Taupo District Council 72 Lake Terrace Taupo

Condition Report

RE: Air Conditioning of Main Building.

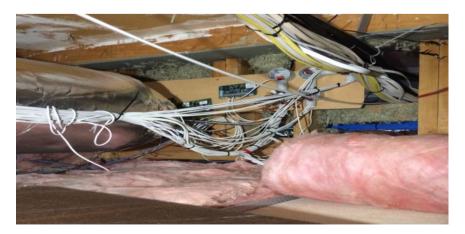
The last upgrade of the offices resulted in many of the office walls being removed allowing for a more open plan arrangement. The changes resulted in the main air system from each floor being affected by the existing ducted systems, ie fighting each other. Also, controlling the temperature in the large space and in small offices was challenging from the one supply system.

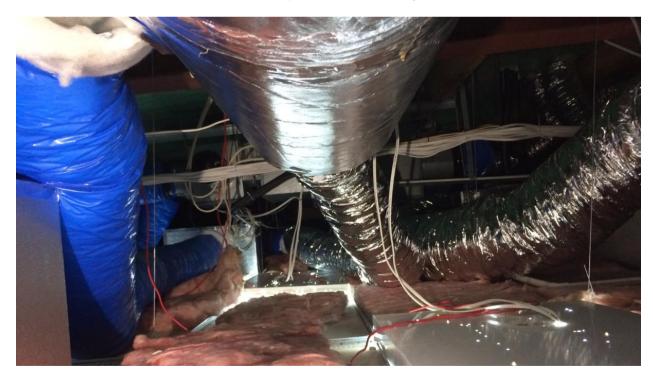
The current ceiling spaces on the ground and top floor are quite congressed with ducting, data cables and power cables. Some of the air conditioning ducting and insulation is redundant and should be removed. The electrical wiring should also be assessed as some of the cables not used have power connected to them.

The insulation has been removed in mainly parts of the ceiling tiles.

Once completed the insulation should be replaced and installed correctly on the tiles to provide the required level of insulation. This will reduce the energy losses in heating and cooling and reduce the electrical energy losses as the air conditioning equipment will be operating on a reduced capacity.

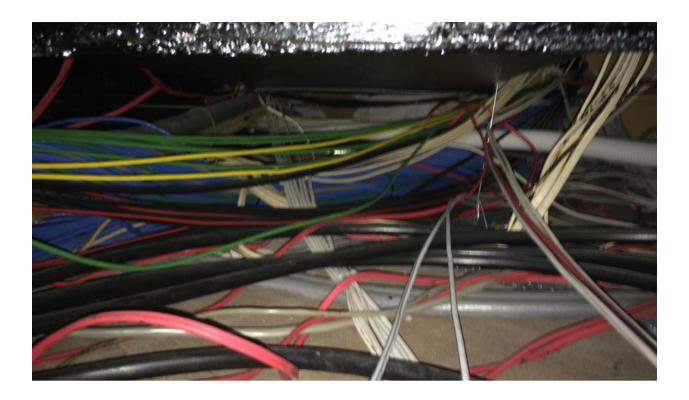
Redundant ducting and loose wiring can cause a fire hazard.

A lot of the existing wiring has not been secure as per the regulations. Power wiring is mixed and tangled with data, fire and communications cable.

- Removal of office furniture in the space
- Ceiling grid to be removed and reinstated
- Removal of the ducting and redundant equipment.
- Fire system to be disconnected to prevent false triggers
- Electrical wiring to be assessed and redundant wiring removed. All existing wiring to be tidied and labeled.
- Fire sensors and wiring to be tidied.
- All fire dampers and fire wall assessed and reinstated to code.
- Office personnel to be relocated during this time (could be up to a month)
